WATTS BAR NUCLEAR PLANT

CONTAINMENT ISOLATION

Corrective Action Program Plan

Revision 0

UPGRADE RECOMMENDED FOR NORMAL CHARGING LINE

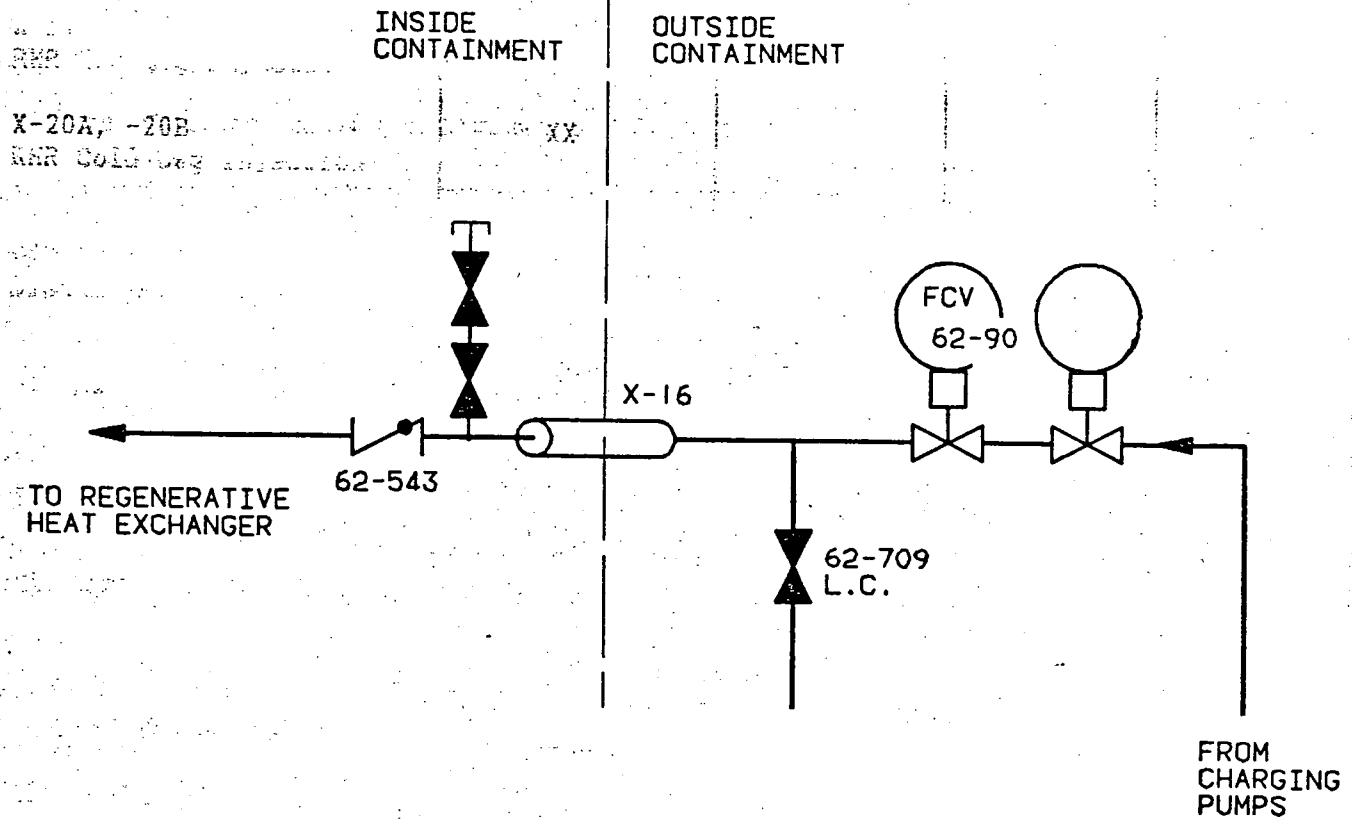
- 62-543 CURRENTLY DESIGNATED AS INBOARD ISO VALVE
- REDESIGNATE FCV-62-90 AND 62-709 AS OUTBOARD ISO VALVES
- 62-709 IS TO BE LOCKED CLOSED
- BRINGS LINE INTO COMPLIANCE WITH GDC 55

UPGRADES RECOMMENDED FOR ECCS AND RHR SPRAY LINES

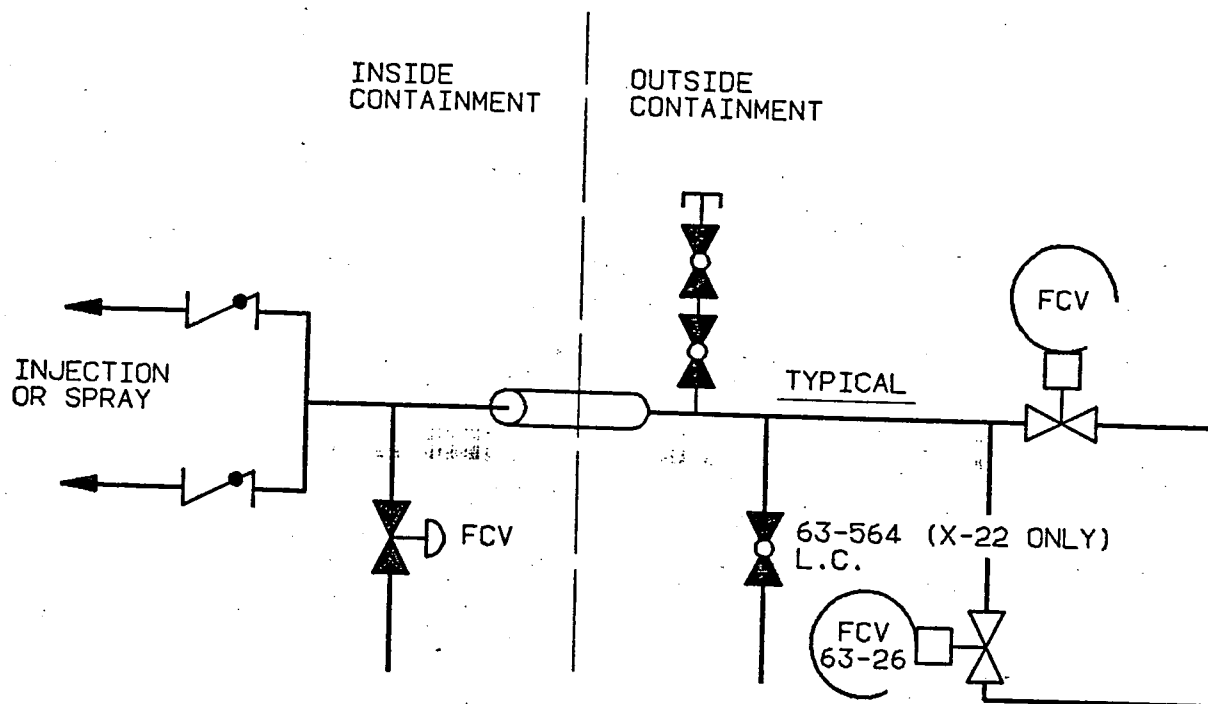
- INBOARD CHECK AND FCV'S CURRENTLY DESIGNATED AS INBOARD ISO VALVES
- REDESIGNATE ABOVE LISTED FCV'S AND 63-564 AS OUTBOARD ISO VALVES
- BRINGS LINES INTO COMPLIANCE WITH GDC 55 OR 56 VIA SRP 6.2.4

UPGRADE RECOMMENDED FOR RELIEF VALVE DISCHARGE LINE

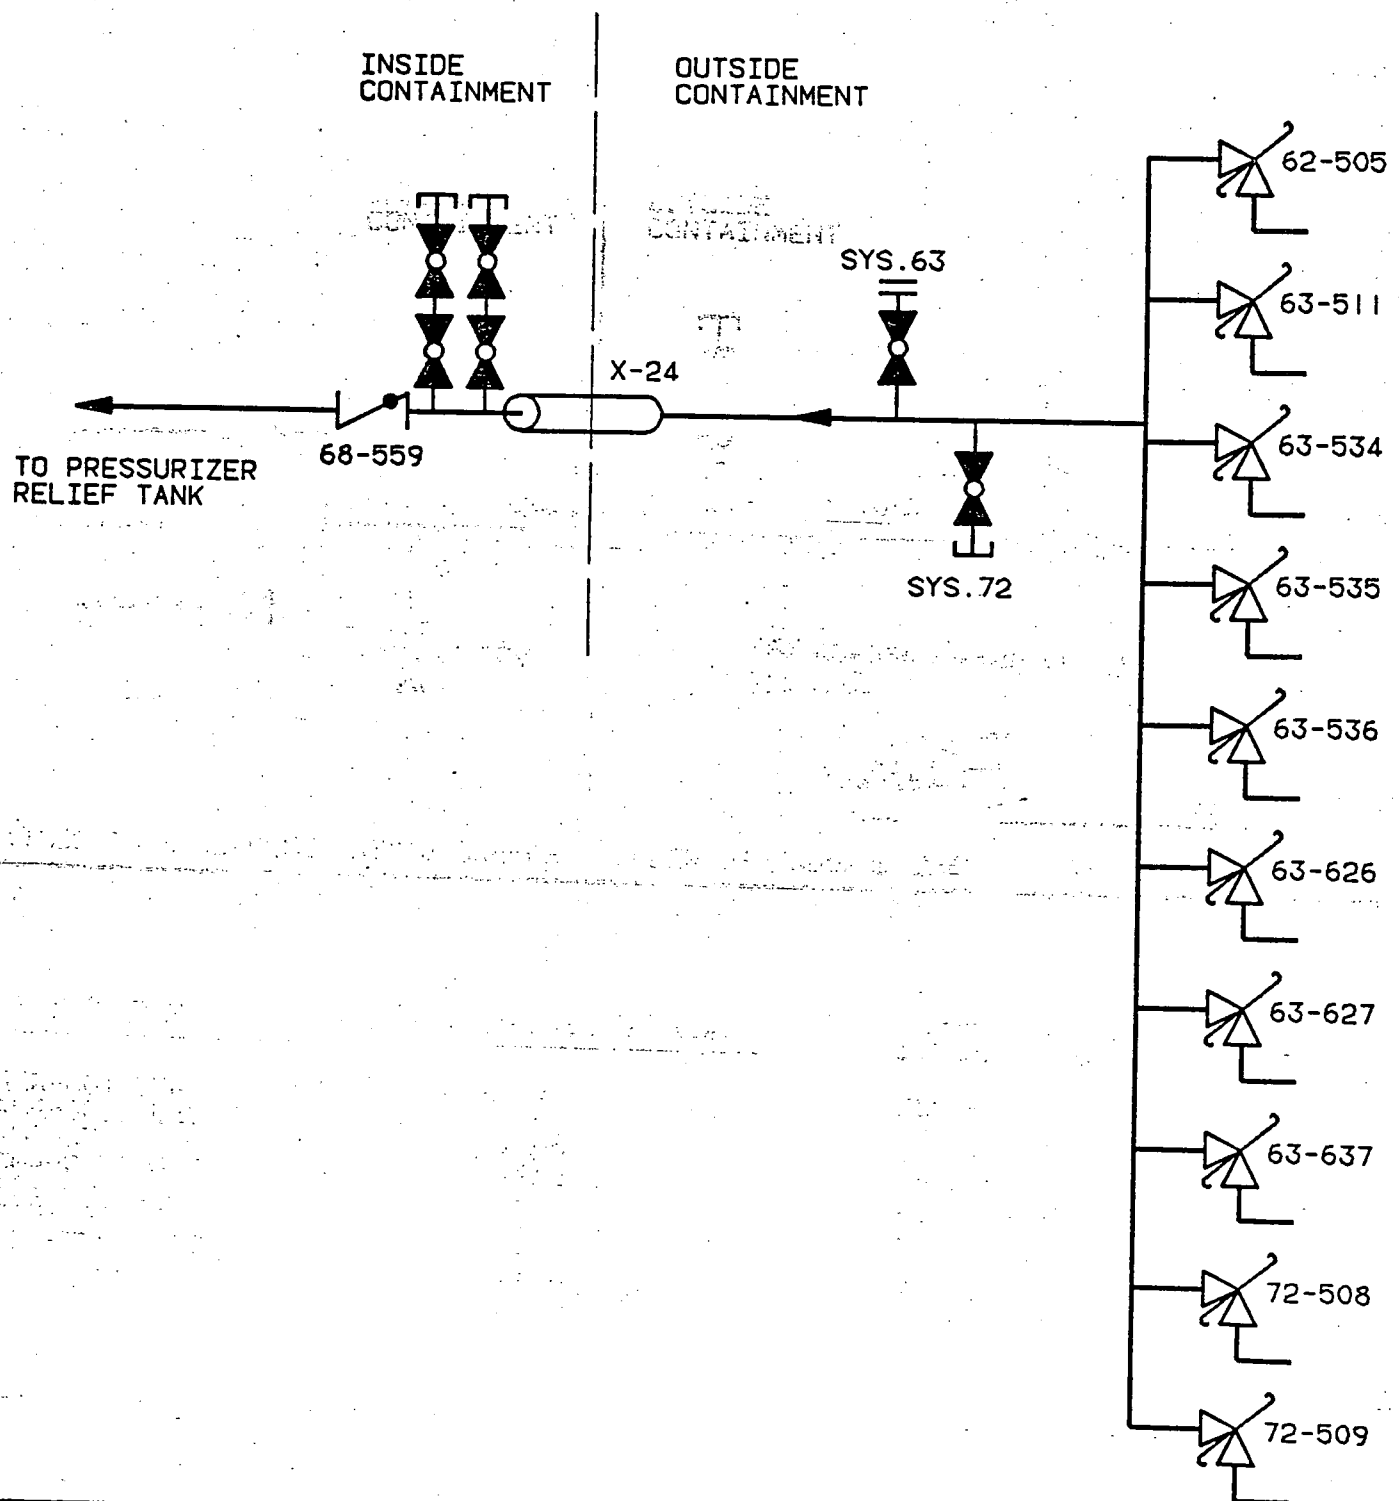
- 68-559 CURRENTLY DESIGNATED AS INBOARD ISO VALVE
- REDESIGNATE TEN RELIEF VALVES AS OUTBOARD ISO VALVE
- BRINGS LINE INTO COMPLIANCE WITH GDC 56 VIA SRP 6.2.4

UPGRADES RECOMMENDED FOR MAIN STEAM LINES

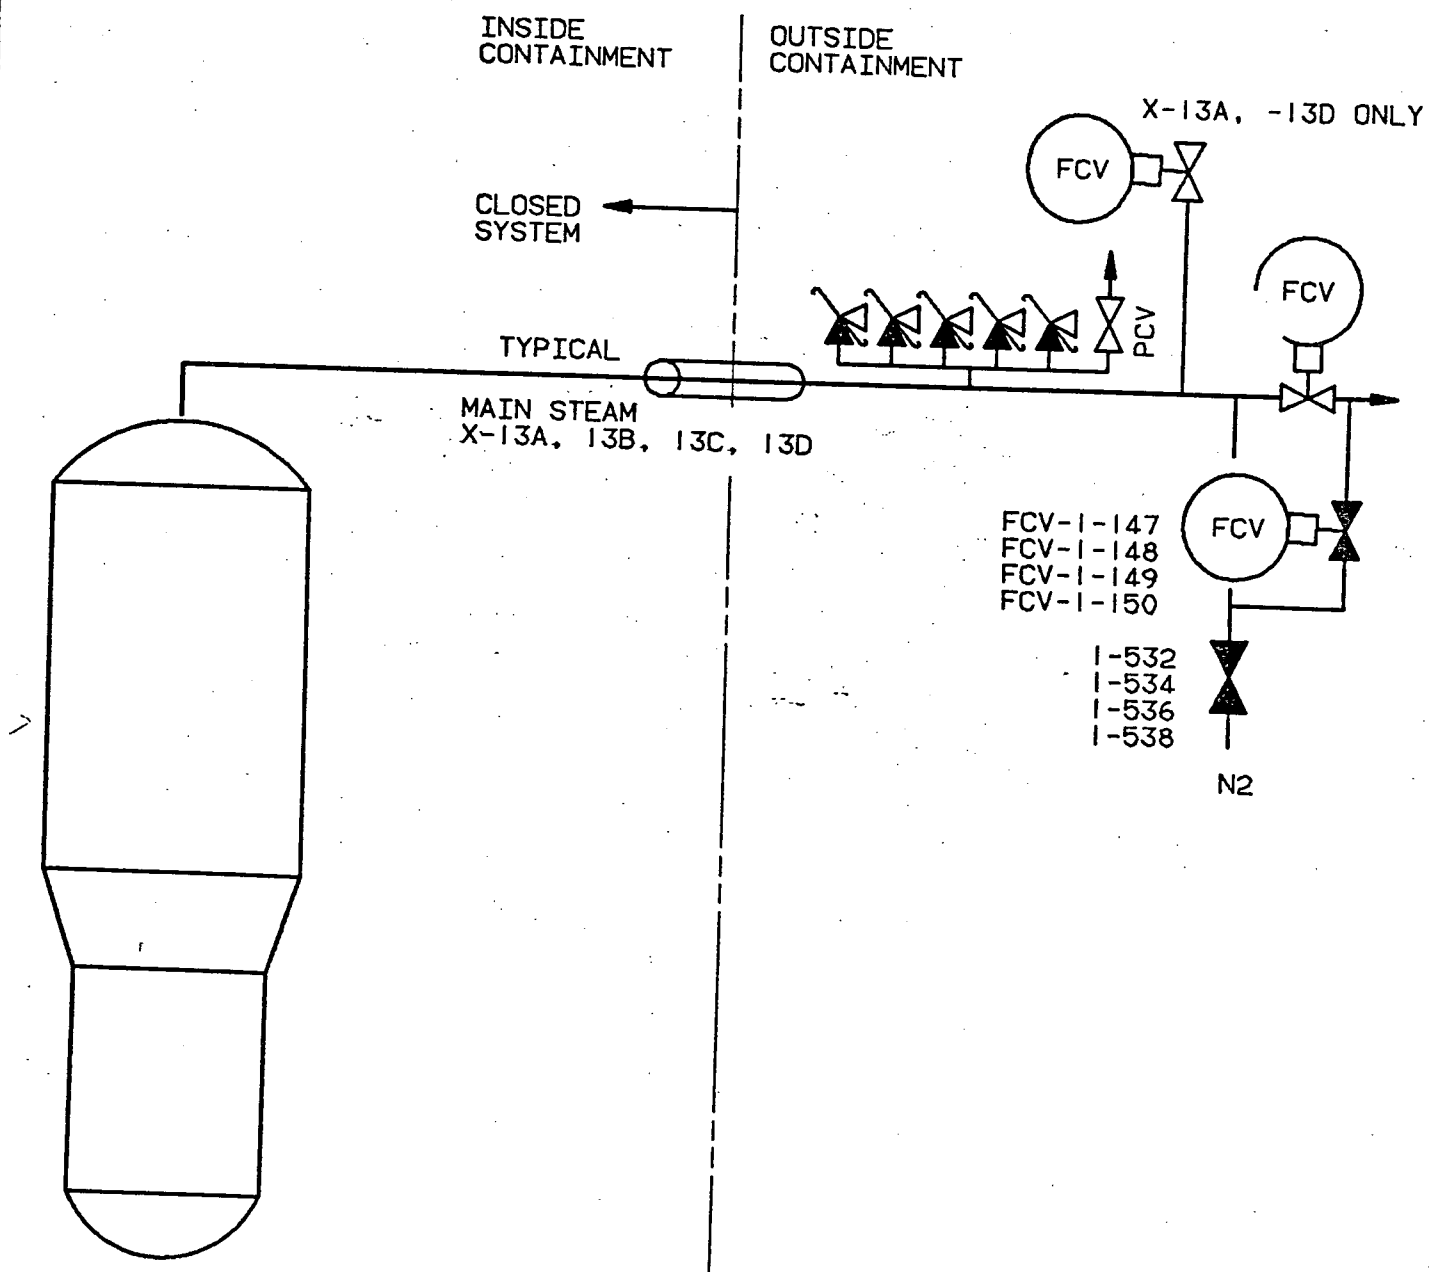
- CLOSED SYSTEM INSIDE CONTAINMENT ON SECONDARY SIDE OF SG. SECONDARY SIDE OF SG FILLED WITH WATER POST-LOCA, TYPICAL OF ALL PWR'S AND FOLLOWS THE PHILOSOPHY OF GDC 57
- FCV'S, PCV'S AND RELIEF VALVES CURRENTLY DESIGNATED CIS VALVES
- ADDITIONAL FCV'S AND LOCKED CLOSED MANUAL VALVES TO BE REDESIGNATED AS CIS VALVES

UPGRADE RECOMMENDED FOR COMPONENT COOLING SYSTEM RELIEF VALVES

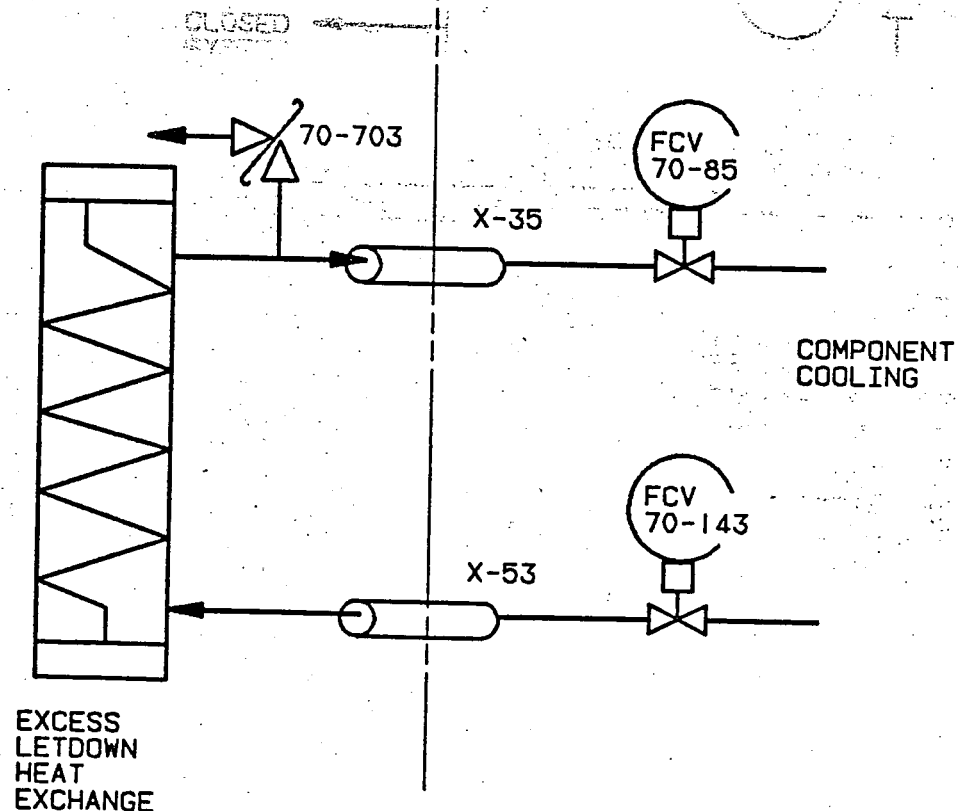
- FCV-70-85 AND -143 CURRENTLY DESIGNATED AS CIS VALVES
- REDESIGNATE 70-703 AS INBOARD ISOLATION VALVE
- BRINGS LINE INTO COMPLIANCE WITH GDC 57 VIA SRP 6.2.4

UPGRADE RECOMMENDED FOR RHR SUPPLY TO PUMPS

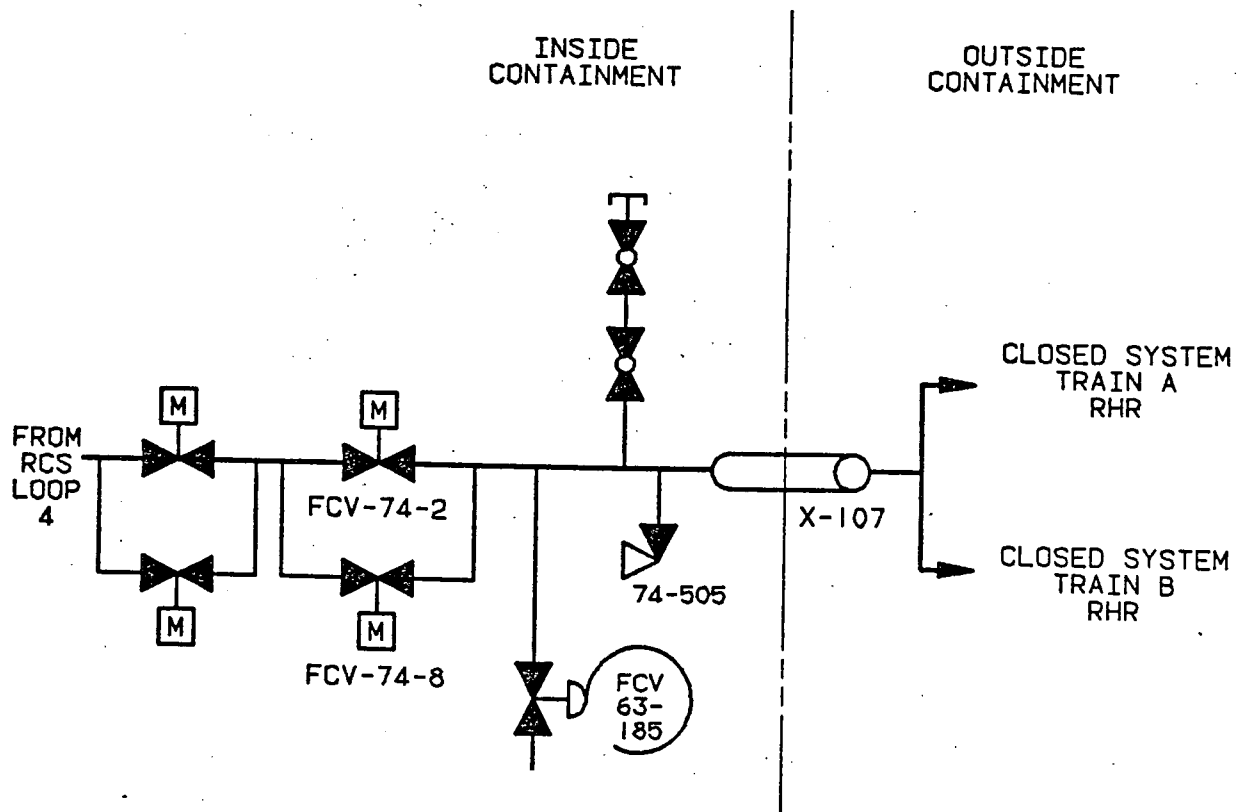
- FCV-74-2 AND -8 ARE CURRENTLY DESIGNATED REMOTE MANUAL CIS VALVES, NORMALLY CLOSED AND INTERLOCKED TO PREVENT OPENING WHEN RCS PRESSURE EXCEEDS RHR DESIGN PRESSURE. IN ACCORDANCE WITH ANSI N271-1976.
- REDESIGNATE 74-505 AND FCV-63-185 AS INBOARD ISOLATION VALVES

UPGRADE RECOMMENDED FOR FEEDWATER LINES

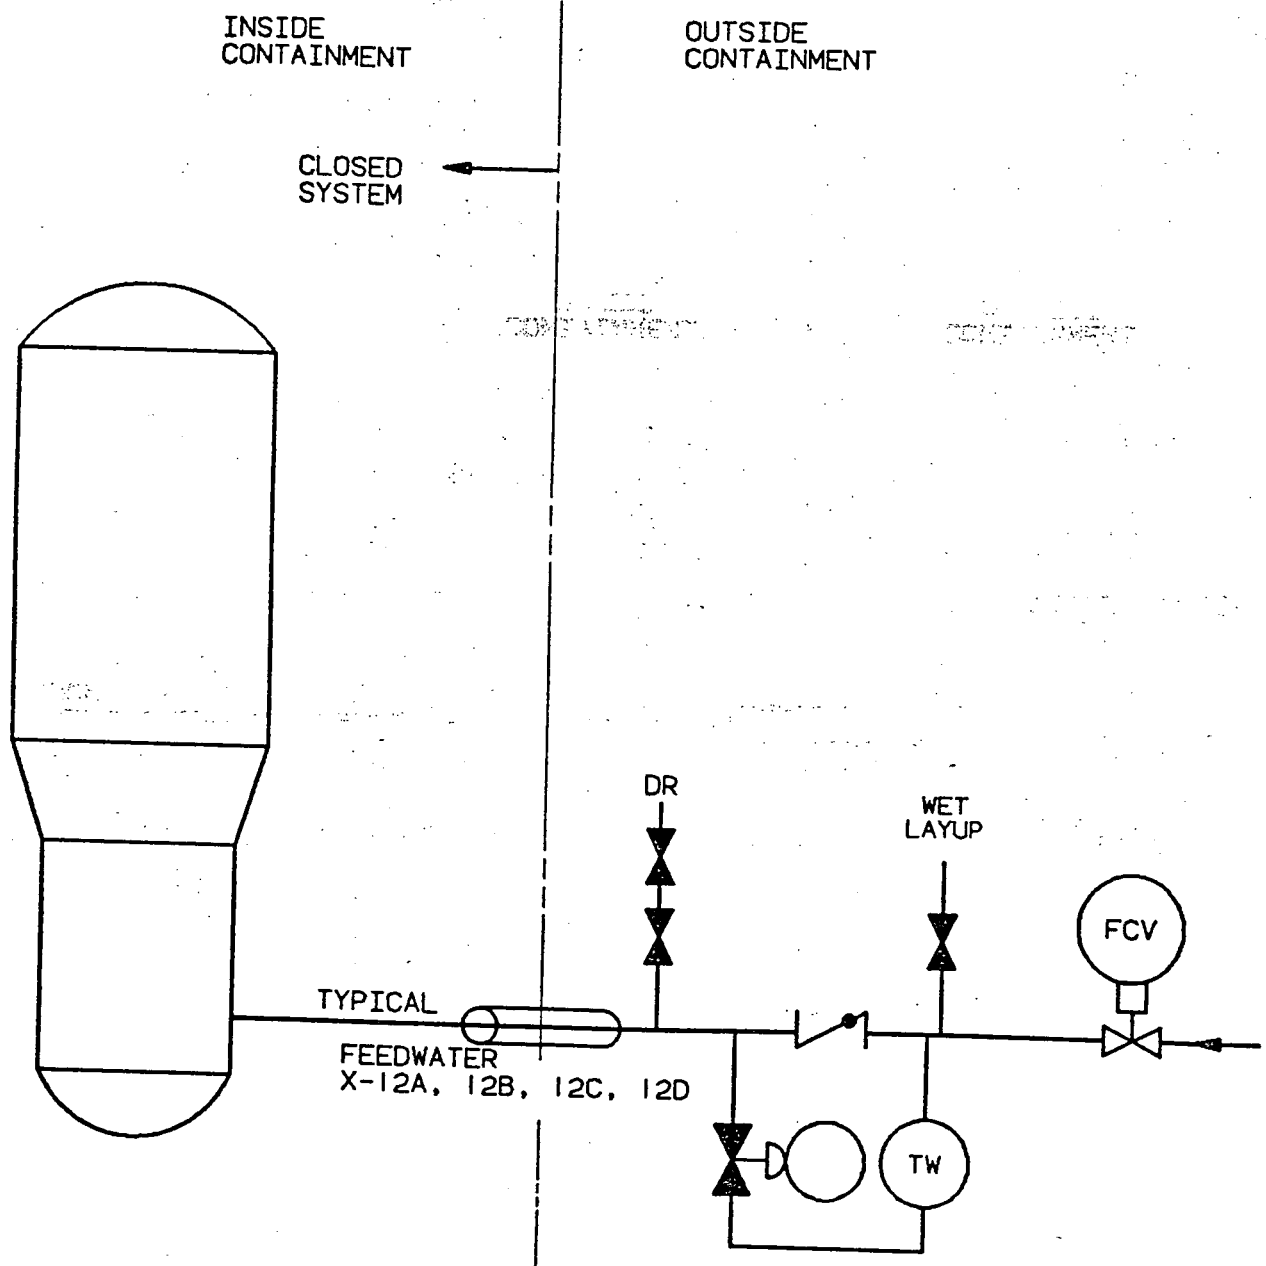
- CLOSED SYSTEM INSIDE CONTAINMENT ON SECONDARY SIDE OF SG. SECONDARY SIDE OF SG FILLED WITH WATER POST-LOCA, TYPICAL OF ALL PWR'S AND FOLLOWS THE PHILOSOPHY OF GDC 57
- FCV'S & MANUAL VALVES CURRENTLY DESIGNATED FOR CIS, MANUAL VALVE TO BE LOCKED CLOSED.

UPGRADE RECOMMENDED FOR R.C. DRAIN TANK PUMP DISCHARGE

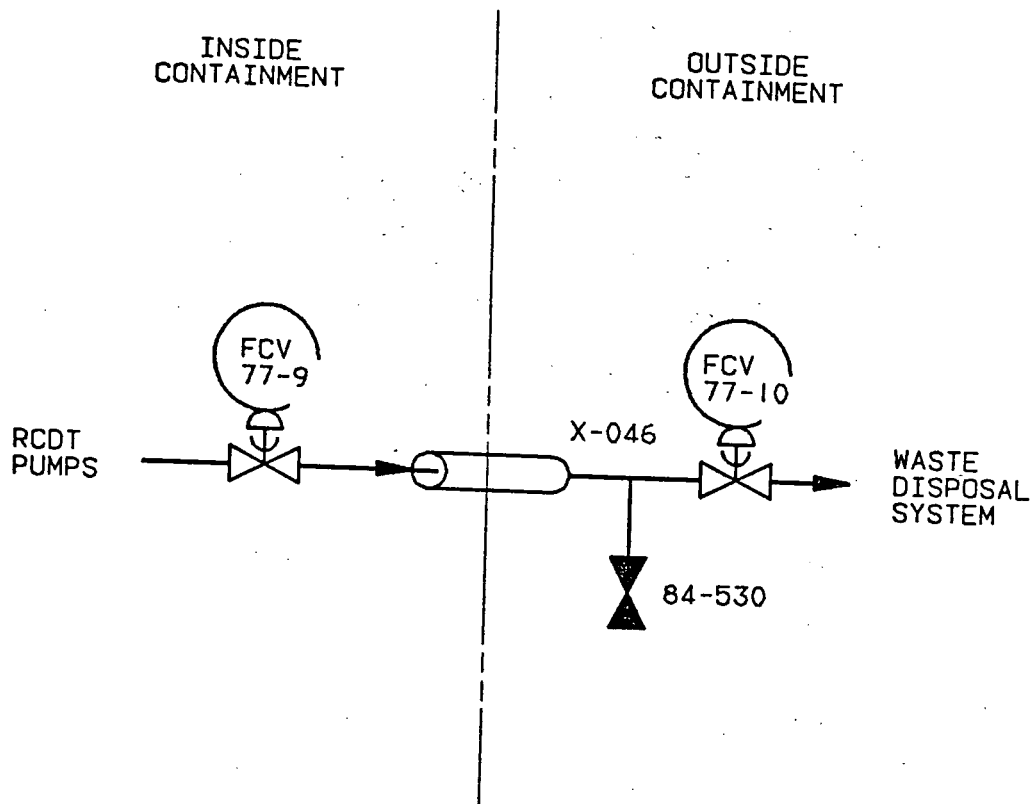
- FCV-77-9 CURRENTLY DESIGNATED AS INBOARD ISO VALVE.
- FCV-77-10 AND 84-530 CURRENTLY DESIGNATED AS OUTBOARD ISO VALVES.
- MANUAL VALVE 84-530 IS TO BE LOCKED CLOSED
- BRINGS LINE INTO COMPLIANCE WITH GDC 56
